Access Compliance Report Public Rights-of-Way (Curb Ramps)

Main Street: MIDWAY_PL Cross Street: BEACH_BLVD Location: SE

ADA ID: RPRK210929154609 Ramp Type: Type 1 - Perpendicular Diagonal Initial Pass/Fail: Fail Overall Compliance: No Severity Score: 30

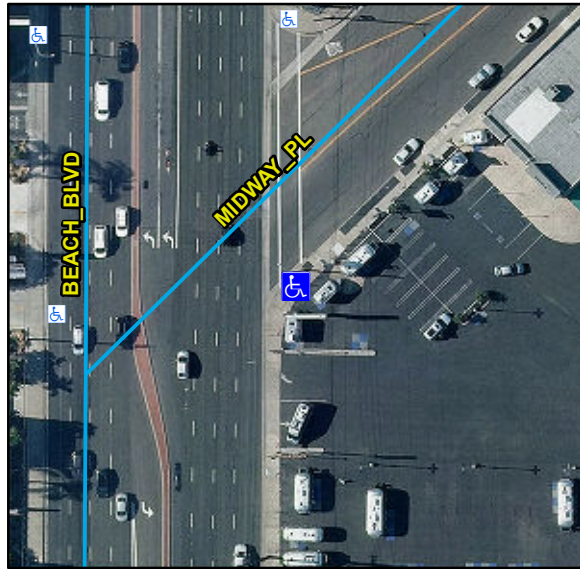
Compliance	Description	Data	Compliance	Description	Data
N/A	Ramp Length (in)	75	N/A	Flare Type LT	
Yes	Ramp Width (in)	48			N/A
No	Ramp Run Slope (%)	15.9	N/A	Flare Slope LT (%)	N/A
Yes	Ramp Cross Slope (%)	0.7	N/A	Flare Traversable LT	N/A
N/A	Landing Present	N/A	N/A	Flare Type RT	
N/A	Landing Length (in)	N/A			N/A
N/A	Landing Width (in)	N/A	N/A	Flare Slope RT (%)	N/A
N/A	Landing Run Slope (%)	N/A	N/A	Flare Traversable RT	N/A
N/A	Landing Cross Slope (%)	N/A	N/A	DWS Provided	N/A
N/A	Landing Movement Obstructed?	N/A	N/A	DWS Contrast	N/A
	Landing Movement Type	N/A	N/A	DWS Length (in)	N/A
N/A	Landing Shared	N/A	N/A	DWS Full Width	N/A
N/A	Clear Space	Yes	N/A	DWS Offset Left (in)	N/A
N/A	Clear Space To Crosswalk (in)	N/A	N/A	DWS Offset Right (in)	N/A
N/A	Marked Crosswalk 1	No	N/A	Marked Crosswalk 2	No
	Crossing 1 Direction	N		Crossing 2 Direction	W
	Marked Crosswalk 1 Width (in)	N/A		Marked Crosswalk 2 Width (in)	N/A

Remove & Replace Curb Ramp With Two New Directional Ramps or Equivalent.

R304.2.2, STD 1115
